RE: Consolidated GHG PSD Permit Application
Diamond Shamrock Refining Company, L.P., a Valero Company
Valero McKee Refinery – Crude Expansion Project
Sunray, Moore County, Texas

Re: Updated Application for a Prevention of Significant Deterioration Air Quality Permit for Greenhouse Gas Emissions – Crude Expansion Project
Diamond Shamrock Refining Company, L.P., a Valero Company
Valero McKee Refinery
Sunray, Moore County, Texas

Valero McKee Refinery
Figure 2-1 Process Flow Diagram

"Friendly Service, No Surprises!"

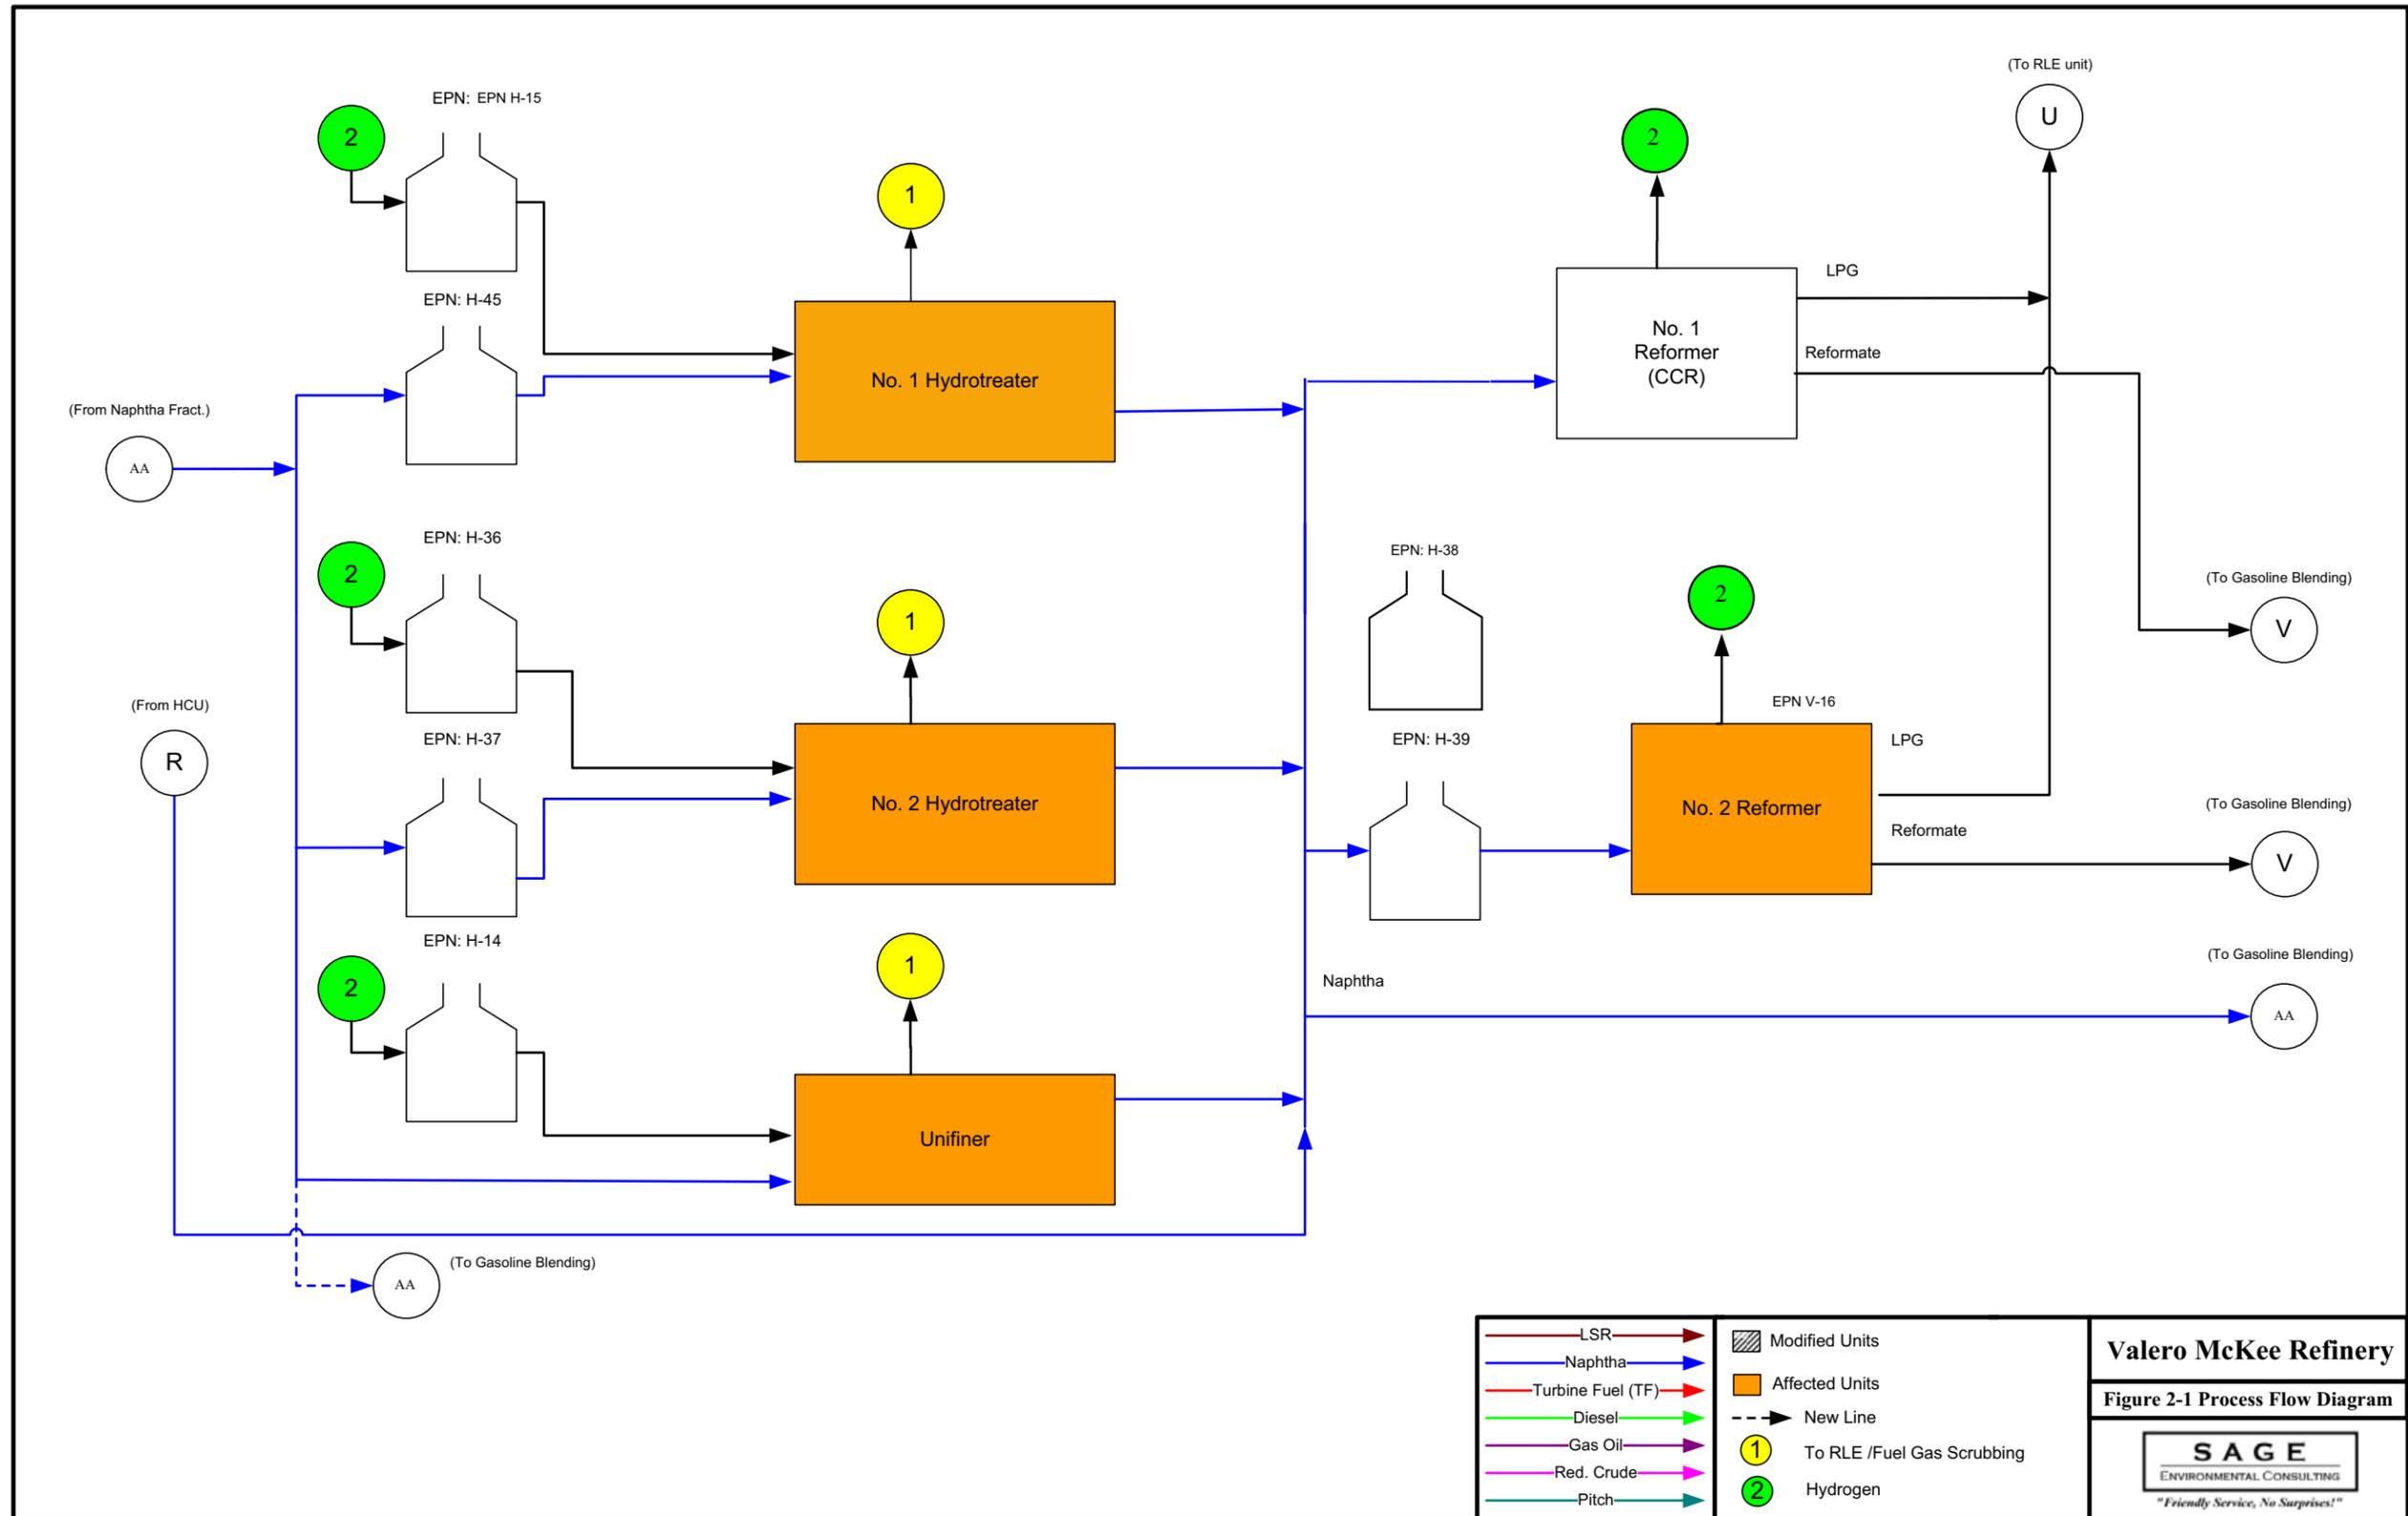
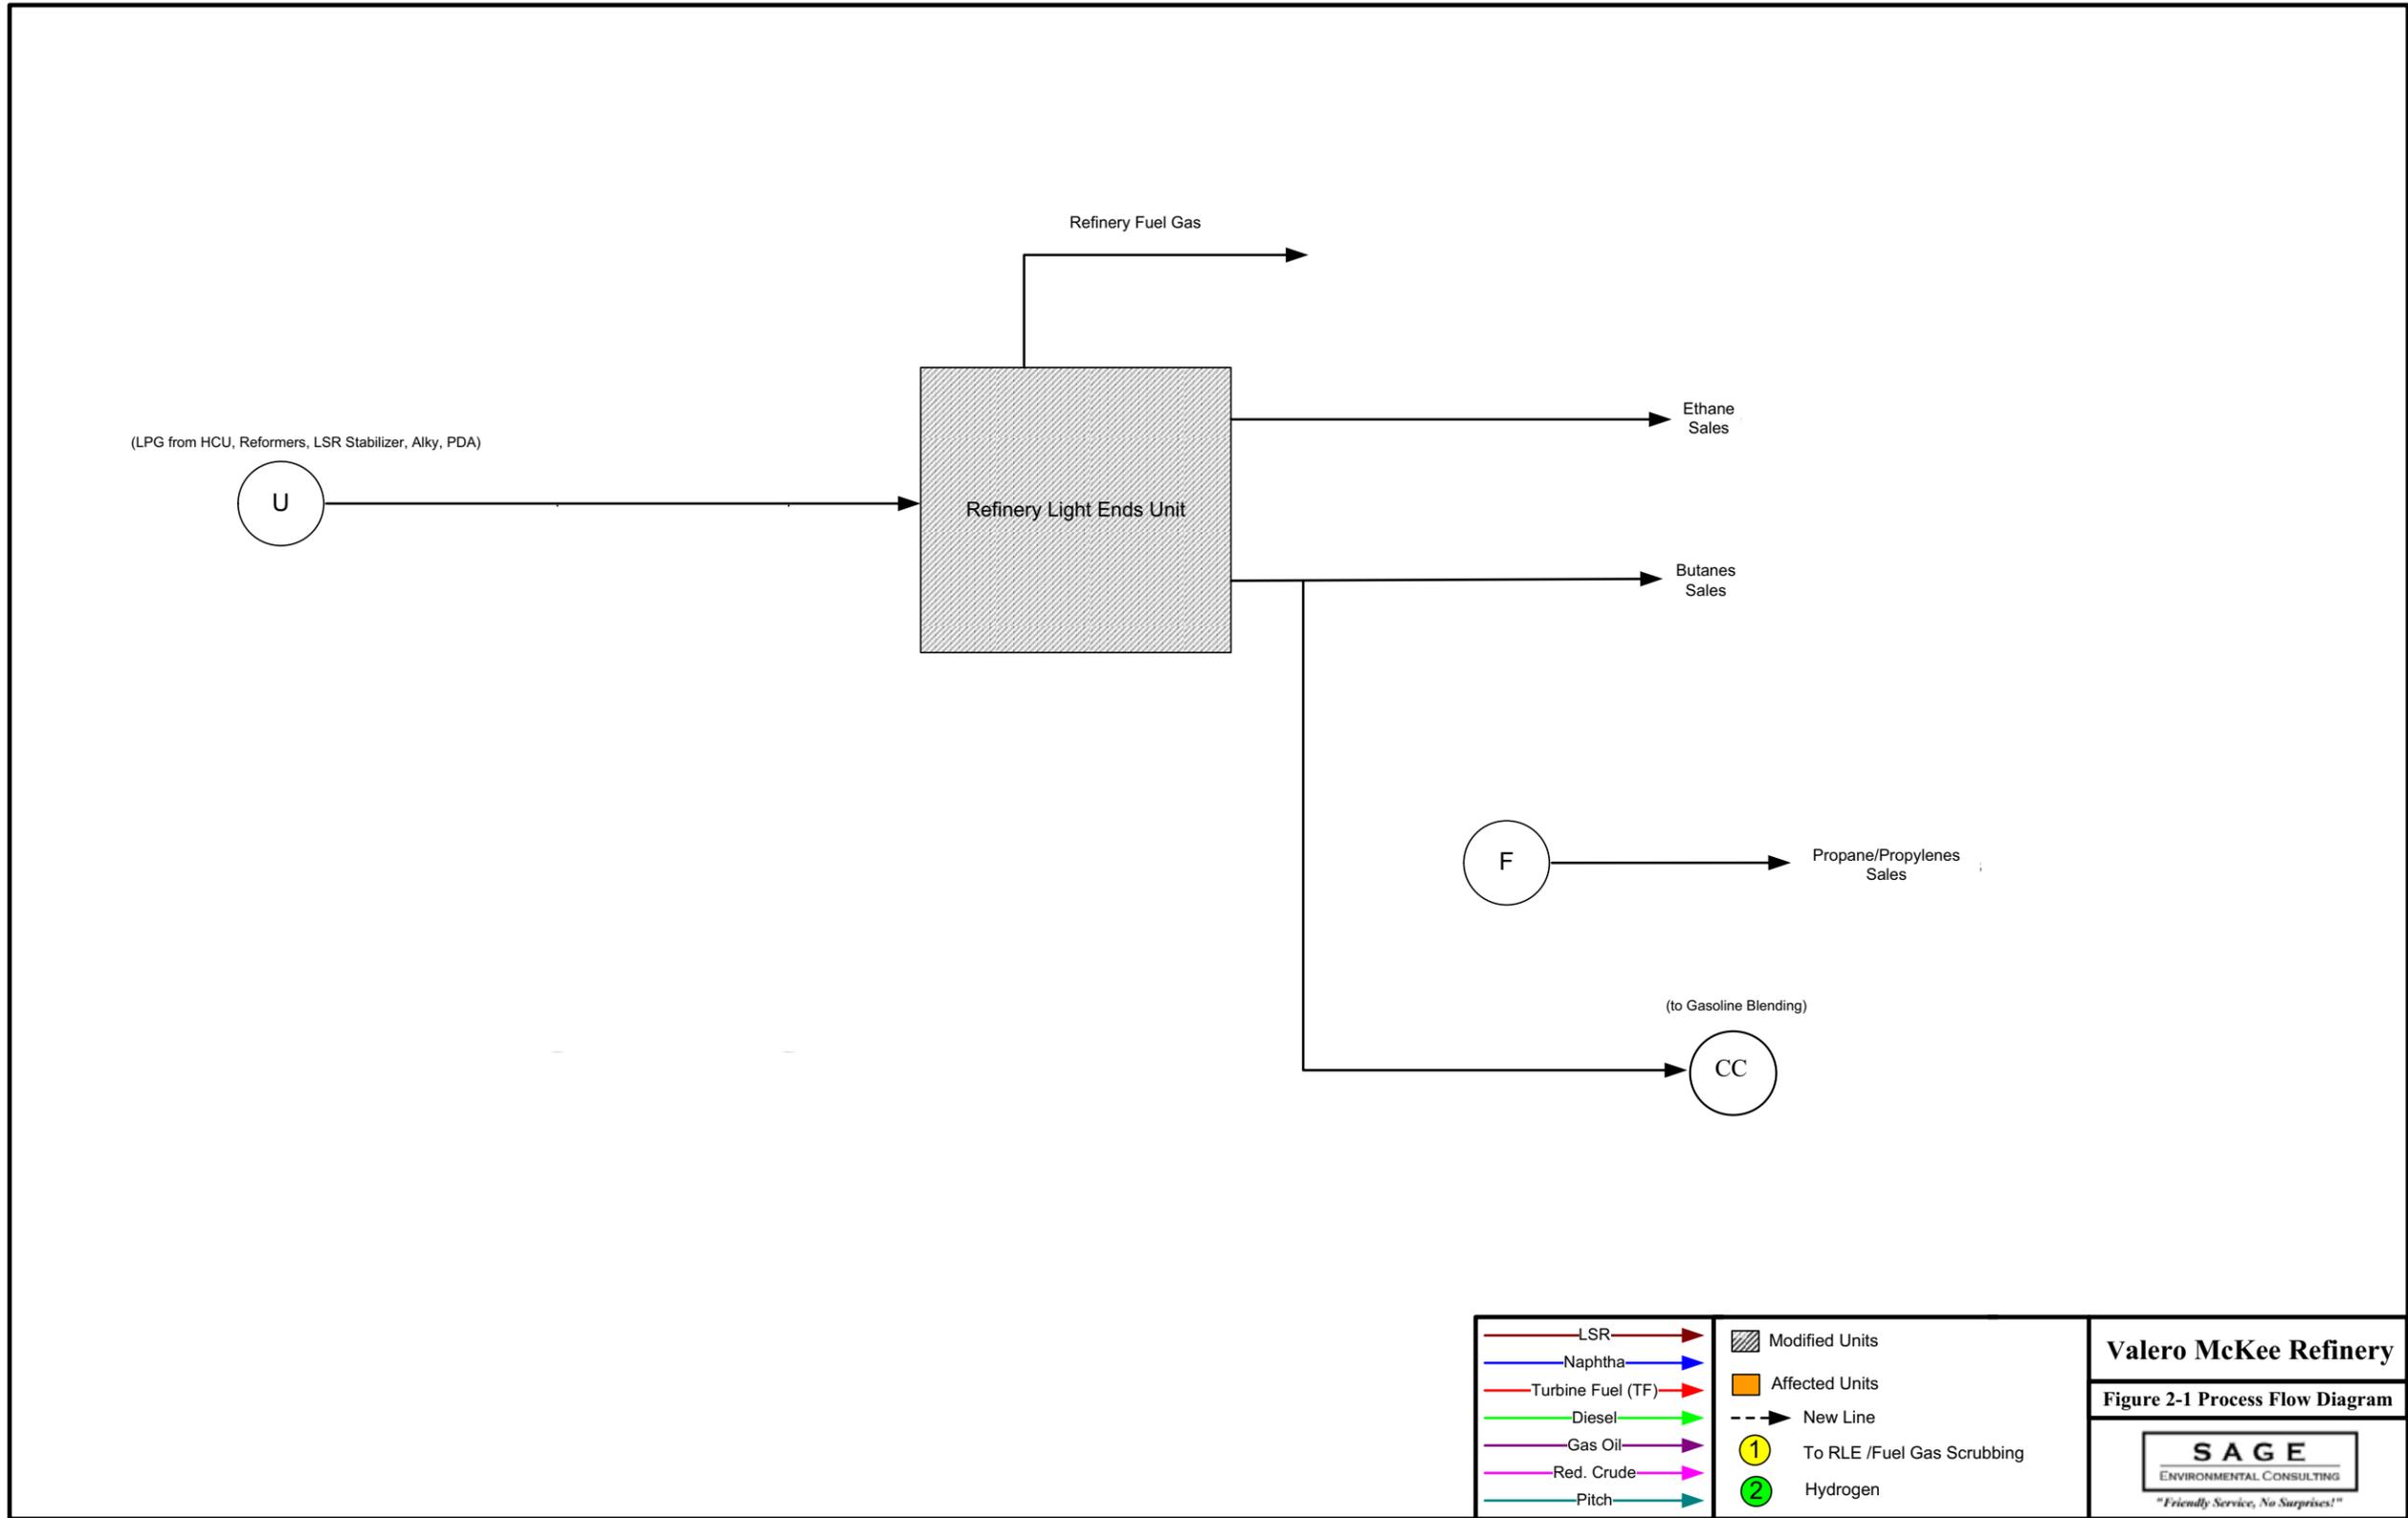
- 1. Figure 2-1 of the application provides a Block Flow Diagram for the entire refinery. Please add simplified block flow diagrams for each process unit indicating the emission points associated with each unit and similar to Figure 2-1. Please indicate if the unit was considered new, modified or affected by the project.**

The Merox unit is identified as modified in overall block flow diagram in Figure 2-1 as well as the description in Section 3. Fugitive emission increases were calculated in Table B-8 and are included in Table B-1 as “Additional Fugitive Components” (Modified). No materials regarding the Merox unit are being revised in this response.
